Evidence Book 2

MOECC Review Document Book

Hidden Quarry ARA Application Package
Technical Reports
Circulated by Applicant
March 2013

Hydrogeologic Impact Assessment
 Proposed Aggregate Extraction
 Part of Lot 1, Concession 6
 Township of Guelph/Eramosa, County of Wellington

Figure 2: Hydraulic Gradient Analysis

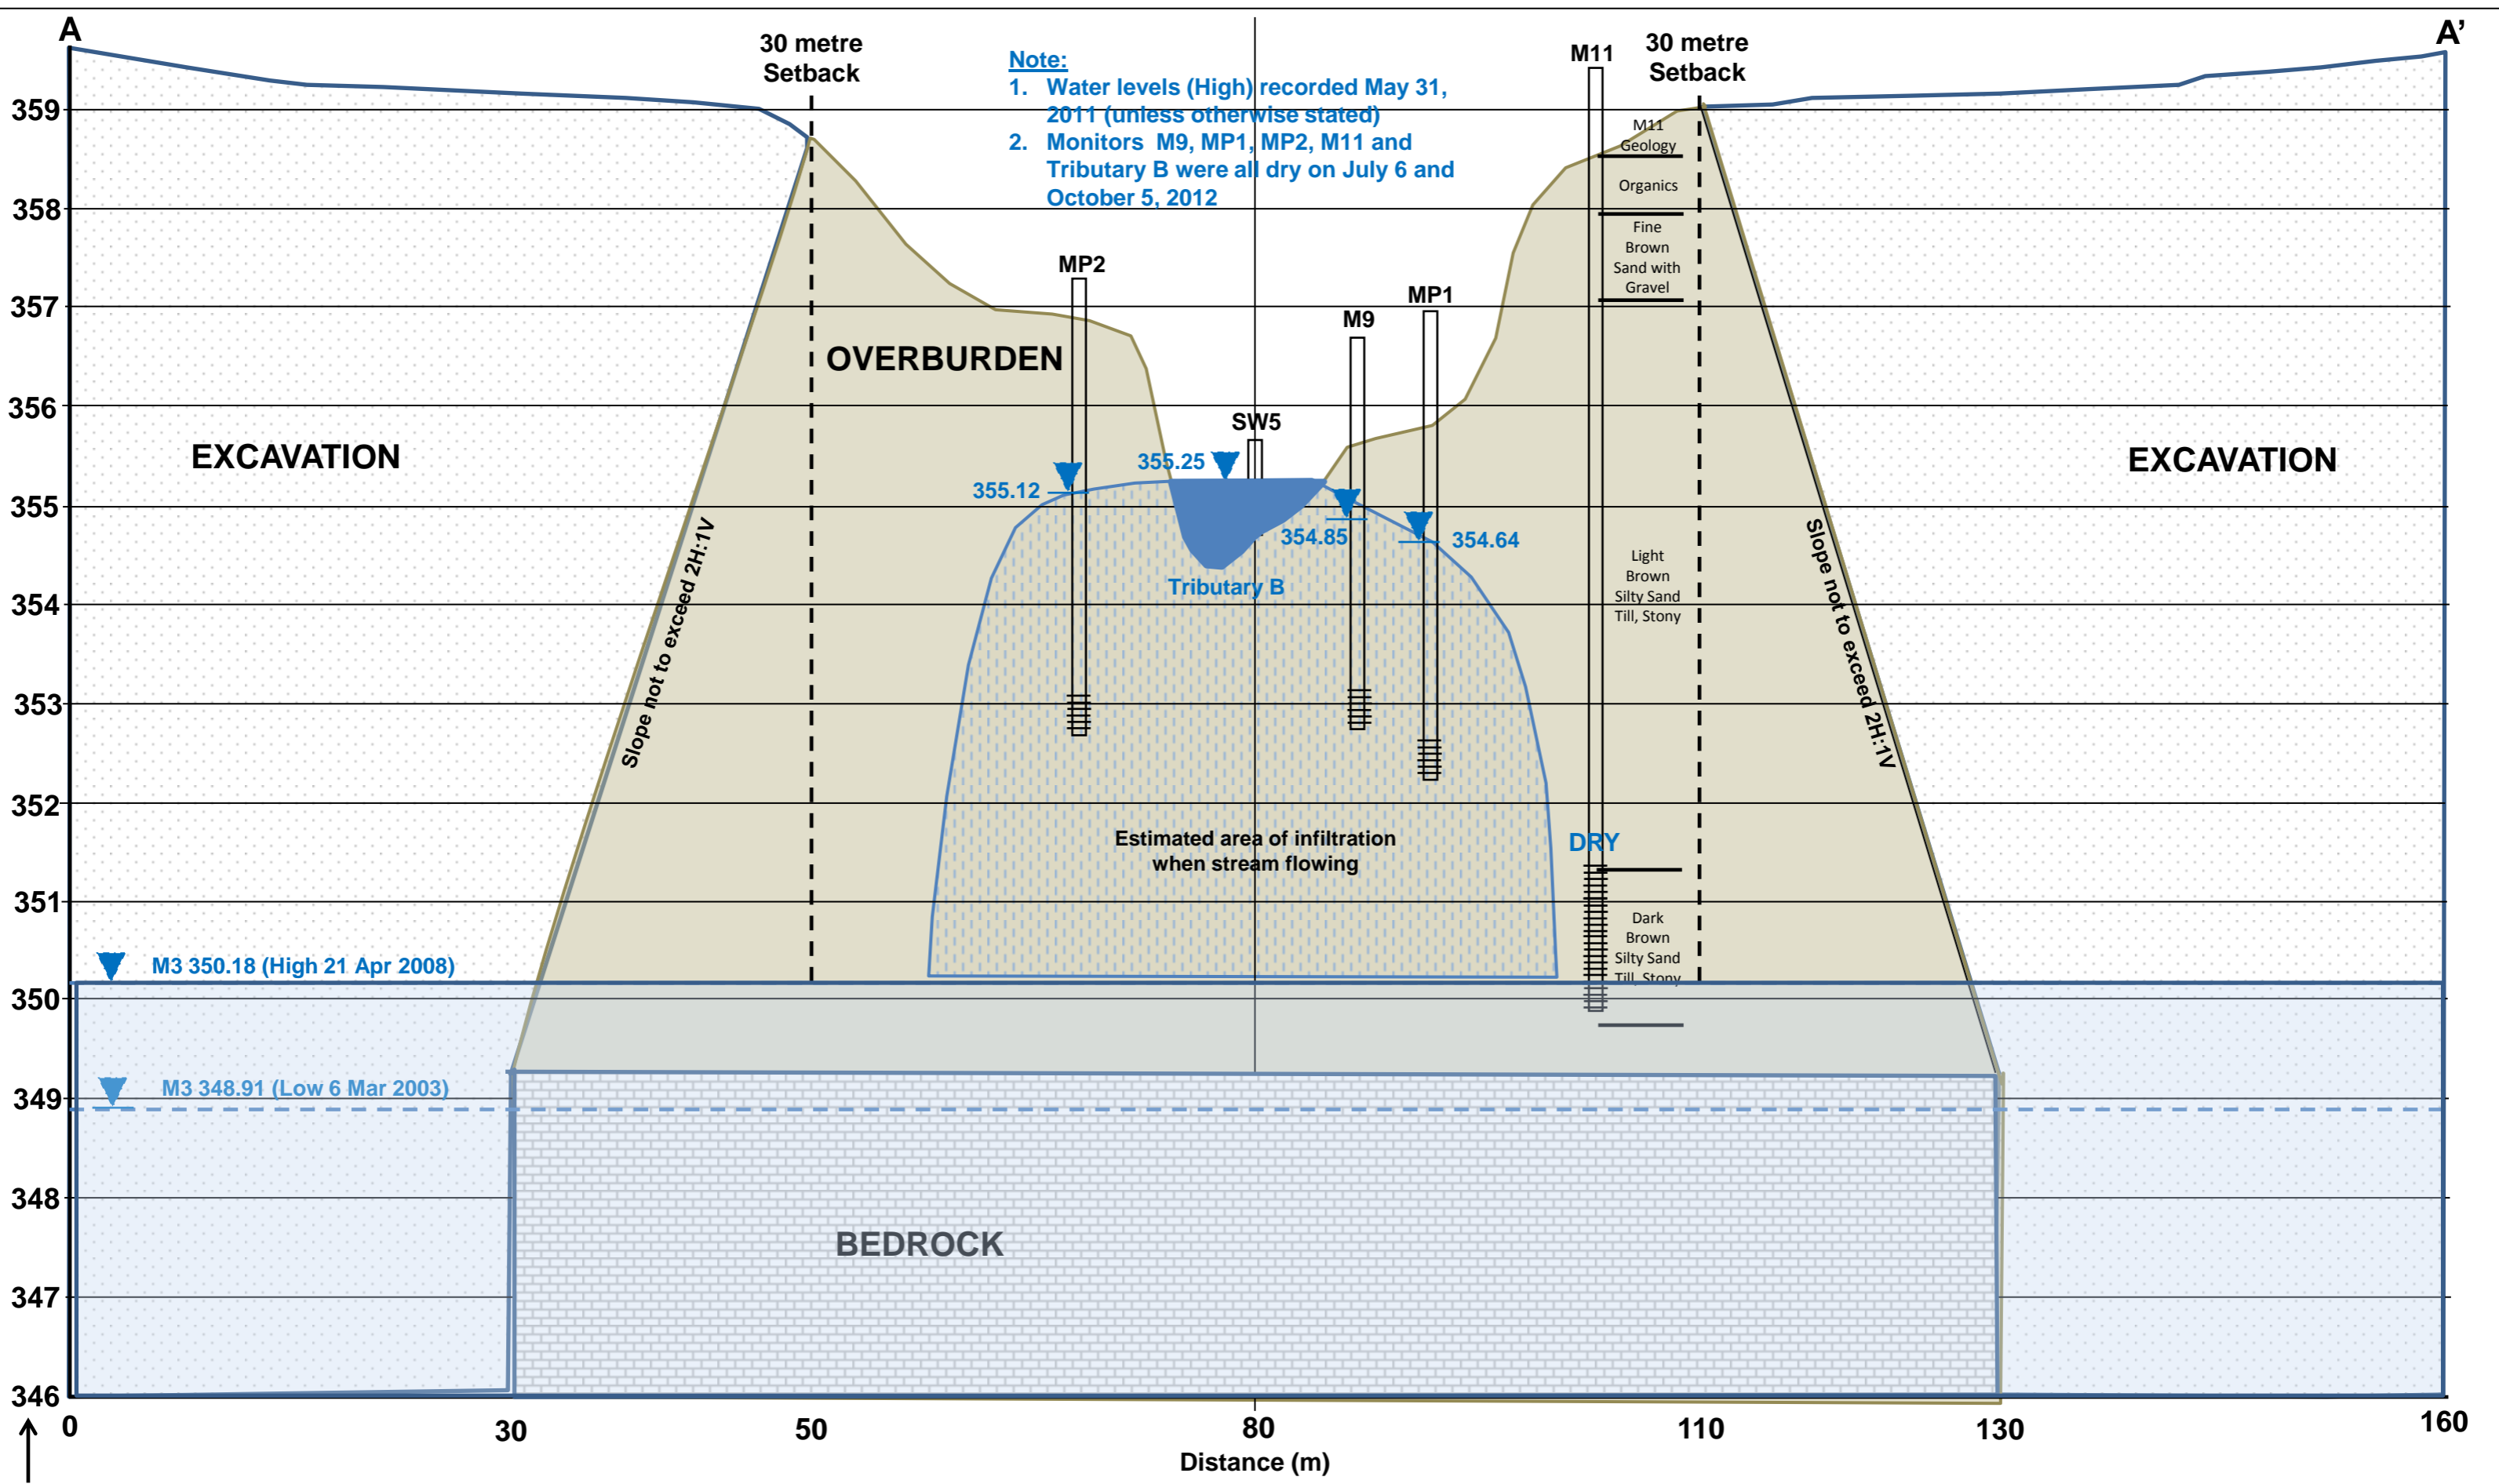
- b. The water level data presented was collected at an approximate monthly frequency; so, the data show the natural seasonal variation of the groundwater water levels in the area. However, during the active rock extraction, specially at the outset, the water levels are expected to fluctuate much more quickly; consequently, it is recommended that, before the commencement of bedrock extraction, bedrock water level data be collected at a frequency of at least once a day for at least one year to generate a baseline dataset. Future water levels fluctuation during the bedrock extraction phases can be compared to the baseline dataset. These future water levels fluctuations should also be measured at a daily frequency as a minimum for a minimum of year, at that point in time the data collected should be assess to establish the frequency of measurements for the life of the quarry.

Figure 2 shows a hydraulic gradient analysis between Tributary B monitoring station SW5 and groundwater monitor M9. For the purpose of this analysis we assume that the creek flow is channelized and the distance from the edge of water to groundwater monitor M9 does not change. The hydraulic gradient ranges from 0.016 m/m to 0.259 m/m. The highest gradients are observed in October/November when the sediments beneath the creek are unsaturated. The lowest gradients occur in the spring after the underlying sediments have been saturated for several months.

The data displayed in Figure 2 shows us that where unsaturated conditions occur, the slope of the infiltrating water from Tributary B is approximately 1V:4H. This is a steep slope and considering that the bedrock aquifer is approximately five metres beneath the creek at SW5, the zone of infiltration will not extend beyond a distance of 20 metres from the creek edge. This condition is confirmed at M11 which is located 23 metres from Tributary B. Although hydraulic gradients decrease in magnitude seasonally, standing water has never occurred in M11 indicating that all infiltrating water intersects the water table in the bedrock aquifer within 23 metres of the creek. No layers of significant permeability contrast are revealed in the drilling log of M11 and no isolated layers of saturated soil were encountered in the drilling of M11.
